CITY PLAN COMMISSION**THURSDAY, SEPTEMBER 5, 2024****FILE NUMBER:** S234-172**SENIOR PLANNER:** Hema Sharma**LOCATION:** between Noel Road and Montfort Drive, south of Lyndon B. Johnson Freeway/ Interstate Highway No. 635**DATE FILED:** August 7, 2024**ZONING:** PD 1110**PD LINK:** Link Currently Not Available**CITY COUNCIL DISTRICT:** 13**SIZE OF REQUEST:** 8.6024-acres**APPLICANT/OWNER:** LBJ Financial Owner, LLC**REQUEST:** An application to replat an 8.6024-acre tract of land containing part of Lot 1 in City Block A/6999 and part of City Block 6999 to create one lot on property between Noel Road and Montfort Drive, south of Lyndon B. Johnson Freeway/ Interstate Highway No. 635.**SUBDIVISION HISTORY:**

PRELIMINARY PLAT

LOT 1, BLOCK A/6999
MONTFORT AND 635 CENTER
PART OF LOT 1, BLOCK A/6999
L.B.J. FINANCIAL CENTER AND
BENING 8.6024 ACRES OUT OF
SAHAR PARK SURVEY, ABSTRACT NO. 1144
CITY OF DALLAS, DALLAS COUNTY, TEXAS
WASTEWATER NO. _____
PAVING AND DRAINAGE NO. _____

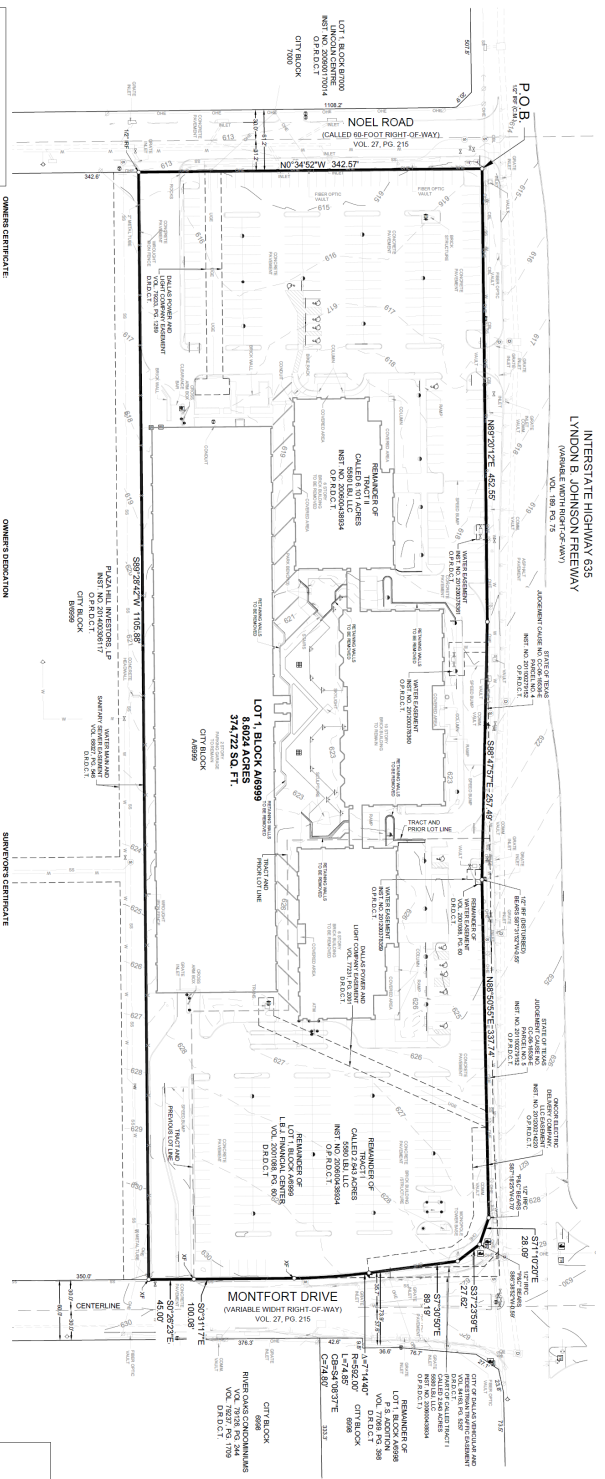
15. On the final plat, dedicate a minimum 20-foot by 20-foot corner clip (via fee simple or street easement) at the intersection of Monfort Drive & Lyndon B. Johnson Freeway/ Interstate Highway No. 635. Section 51A 8.602(d)(1)
16. On the final plat, dedicate a minimum 20-foot by 20-foot corner clip (via fee simple or street easement) at the intersection of Lyndon B. Johnson Freeway/ Interstate Highway No. 635 & Noel Road. Section 51A 8.602(d)(1)
17. A larger corner clip may be requested during engineering plan and traffic review to accommodate an adequate turning radius, or to maintain public/traffic appurtenances, within the area of the corner clip. *Section 51A 8.602(d)(1), 51A 8.608(a)*

18. On the final plat, add the note: "TxDOT approval may be required for any driveway modification or new access point(s)."
19. Must coordinate with Transportation Department for any traffic signal requirements that are deemed necessary for improving pedestrian accessibility and safety related to site development (Contact Srinivasa Veeramallu with Traffic Signals). 51A-8.606, 51A-8.608

20. Prior to final plat, submit a completed final plat checklist and all supporting documents.
21. On the final plat, show recording information on all existing easements within 150 feet of the property.
22. On the final plat, show easement volume 69104, page 699, D.R.D.C.T.

23. Engineer must furnish plans for water and sanitary sewer. Developer must furnish a contract for water and sanitary sewer. Sections 49-60(g)(1) and (2) and 49-62(b), (c), and (f).

24. Additional design information is required for assessment. Site plan must be submitted showing proposed development, building finished floor elevation, development, existing mains – including downstream manhole, and proposed water and wastewater service locations. Submit water/wastewater engineering plans to 320 E. Jefferson Blvd., Room 200, Attention: Water and Wastewater Engineering.

25. Water main improvements is required by Private Development Contract. Submit water/wastewater engineering plans to 320 E. Jefferson Blvd., Room 200, Attention: Water and Wastewater Engineering.

26. Capacity of existing wastewater system is questionable. Submit proposed wastewater discharge (gpm) of development for further assessment. Sections 49-60(b)(2)(d) and 49-60(d).

27. Prior to final plat, compliance with City's Street lighting standards including illumination standards, material, installation, and activation per Street Design Manual.
28. On the final plat, change "Interstate Highway 635 Lyndon B. Johnson Freeway" to "Lyndon B. Johnson Freeway/Interstate Highway No. 635". Section 51A-8.403(a)(1)(A)(xii).
29. On the final plat, identify the property as Lot 1A in City Block A/6999.
